CITY PLAN COMMISSION**FILE NUMBER:** PLAT-25-000170**THURSDAY, January 15, 2026****SENIOR PLANNER:** Hema Sharma**LOCATION:** bounded by Jackson Street, Lamar Street, Wood Street, and Austin Street**DATE FILED:** December 18, 2025**ZONING:** CA-1(A)**CITY COUNCIL DISTRICT:** 14**SIZE OF REQUEST:** 0.918-acres**APPLICANT/OWNER:** Metro Dallas Downtown Investments, LLC

REQUEST: An application to replat a 0.918-acre tract containing all of Lots 1 through 8 in City Block 35/50 to create 0.536-acre lot and one 0.382-acre lot on property bounded by Jackson Street, Lamar Street, Wood Street and Austin Street.

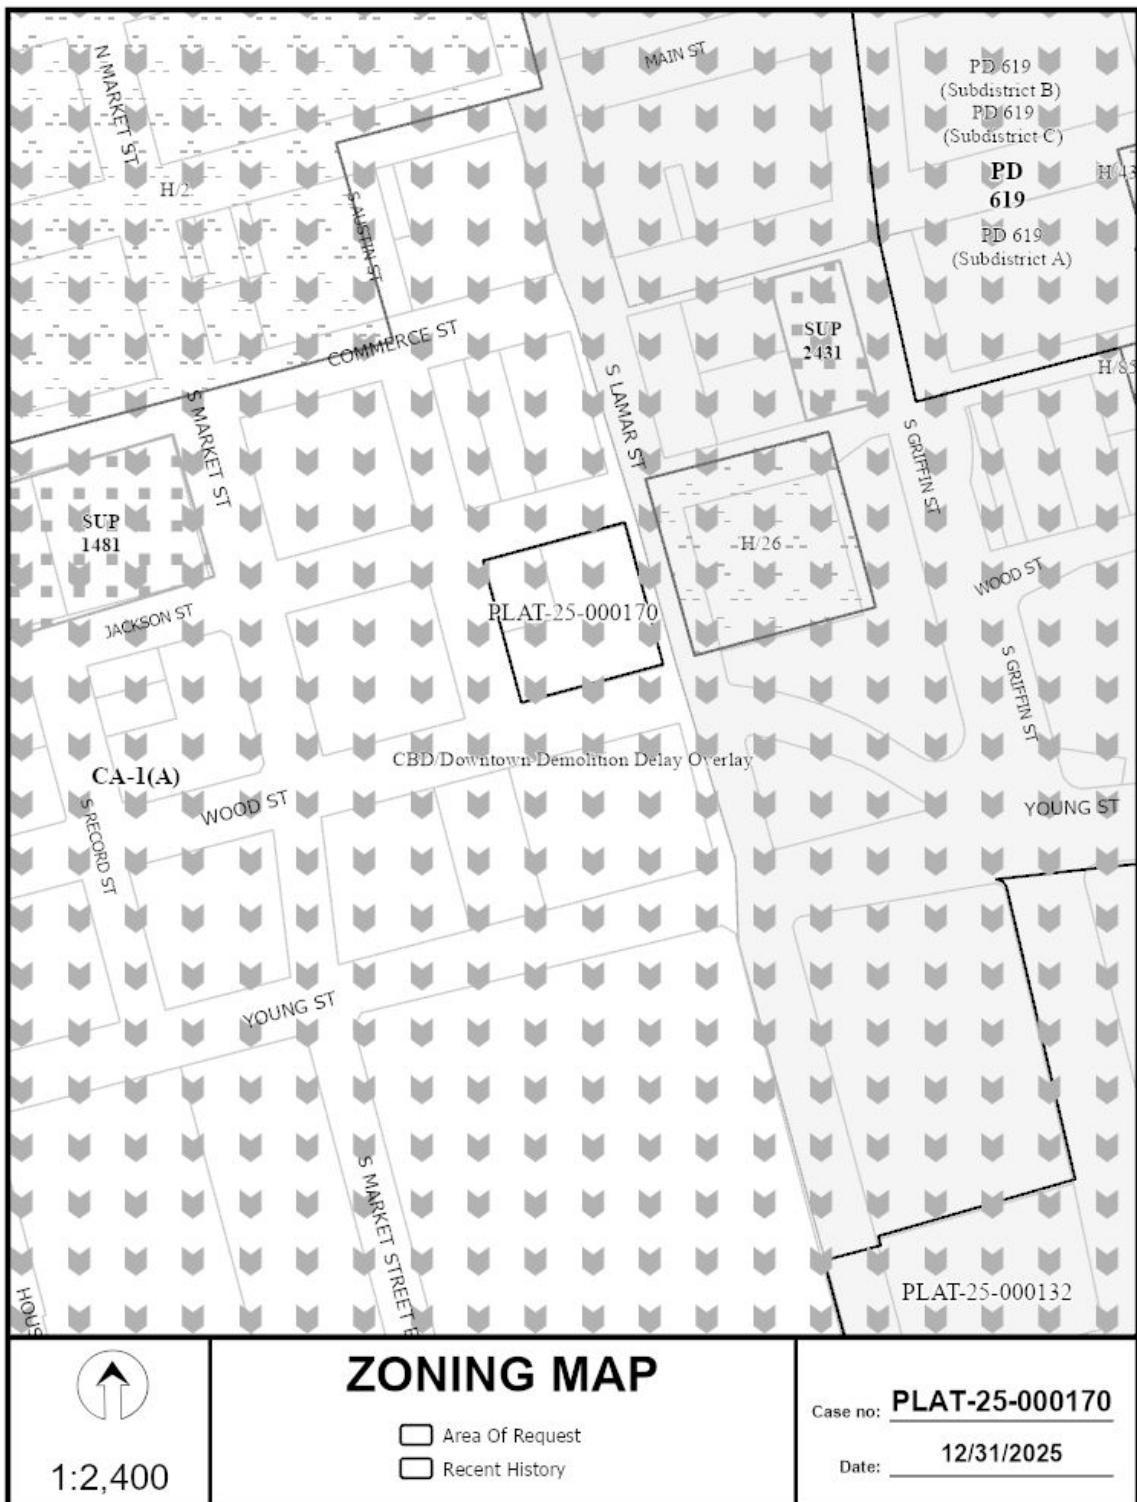
21. Prior to final plat, submit a completed final plat checklist and all supporting documents.
22. On the final plat, show how all adjoining right-of-way was created. Section 51A-8.403(a)(1)(A)(xxii).
23. On the final plat, show all additions or tracts of land within 150 feet of the property with recording information. *Platting Guidelines*.
24. Set monuments not in compliance with the City Monument Ordinance need to be approved by the City Surveyor, Public Works Department through the Alternate Monument Request form.
